Design- Build Technical Criteria
Andrews Hall Renovation - PR 002504
Addendum No. 1
December 14, 2007

Andrews Design- Build Technical Criteria – Addendum No. 1 (continued)

Decorative Metal Grill Examples

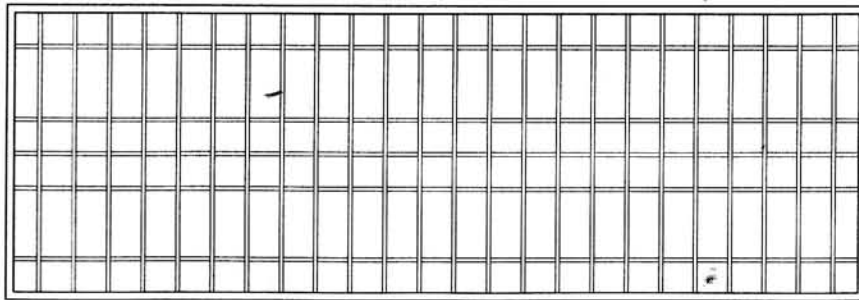
3. On page 22, under “Great Room, Other Design Considerations,” **ADD**: “Fireplace treatment: provide decorative metal grill fabricated with black powder-coated bar stock with wire mesh lining. See Attachment 1 for design examples.”

Common Bathroom Vanity Profile

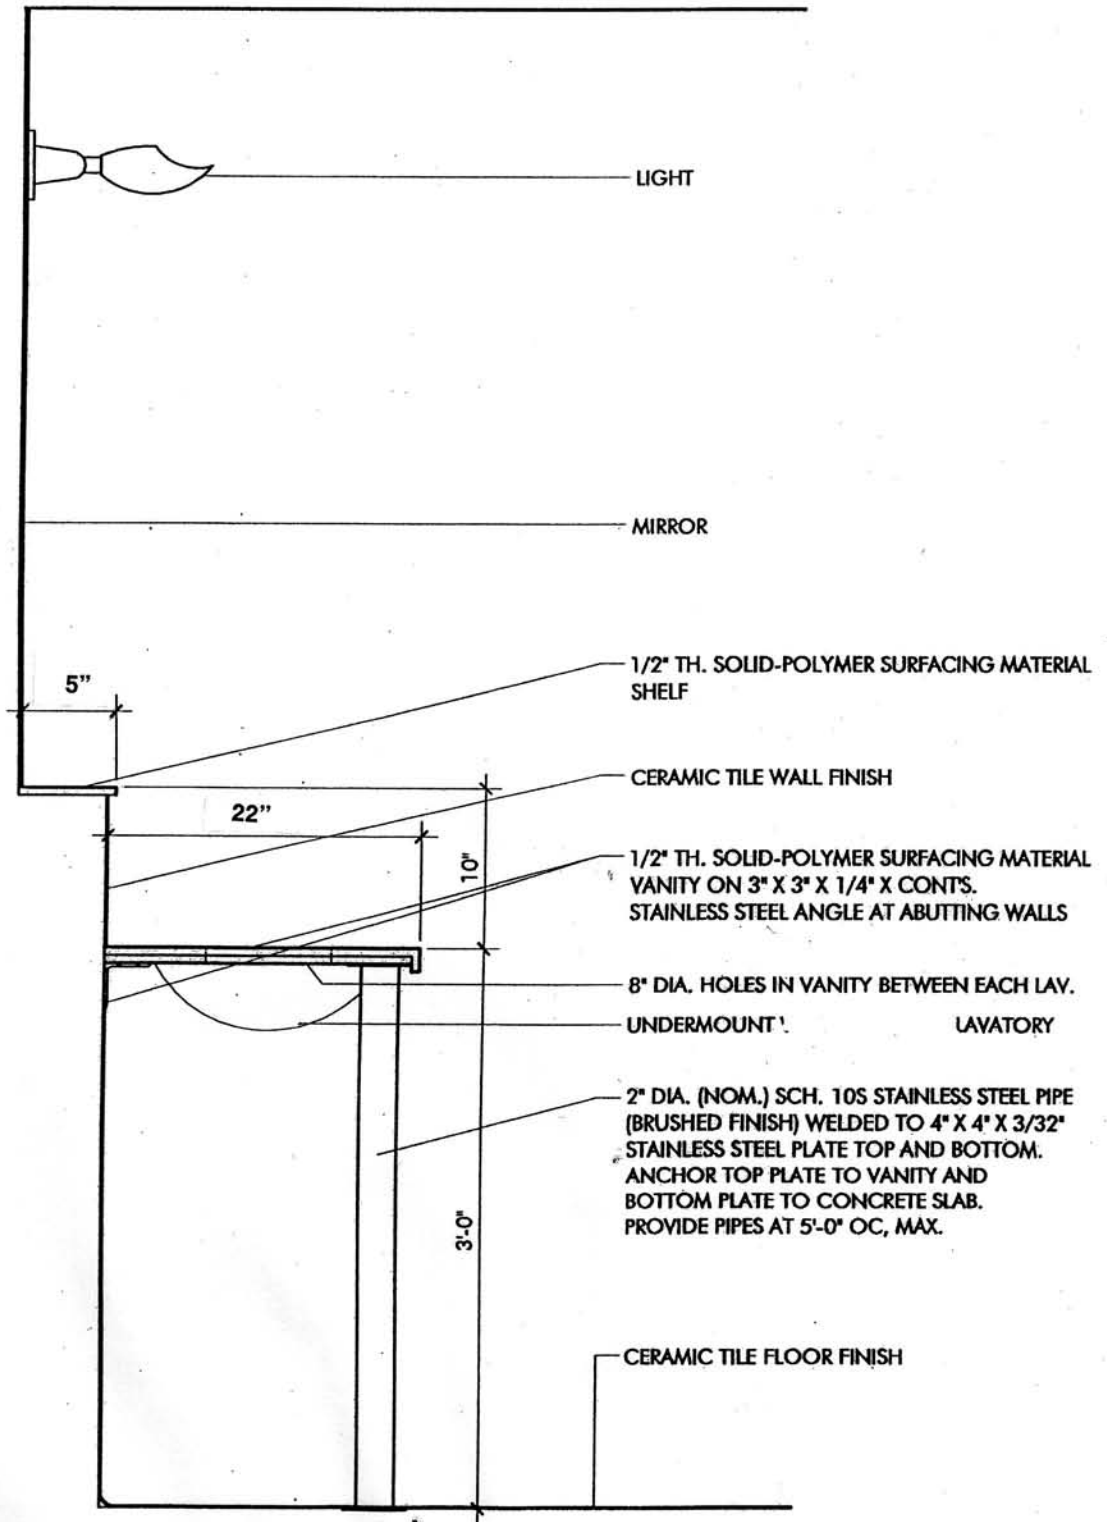
12. Page 54, dimensions on the Common Bathroom Vanity Profile have been **REVISED**. See Attachment 2.
13. On page 56, under “CHILLED WATER SYSTEMS, C.,” **ADD**: “The Chilled Water pipes for the future connections will be routed through the north foundation wall of the west building (mechanical room) and extend 5 feet beyond the wall, where they will be capped with flanges and blind flanges on the end. The pipes will transition from carbon steel to PVC-80 with butterfly valves and flanges before penetrating the foundation wall and will continue to be PVC-80 to the end. The PVC-80 lines will be insulated per UCB specifications in the mechanical room and will not be insulated through the foundation wall or outside of the building. The insulation at the foundation wall will be sealed to prevent condensation. The penetration of the foundation wall will be sealed using Link-Seal. The exterior piping will be bedded with a minimum of 6" of pea-gravel on undisturbed soil. The sides and top will be surrounded with pea gravel, with a minimum of 6" on top. Backfill will be free of large stones.”
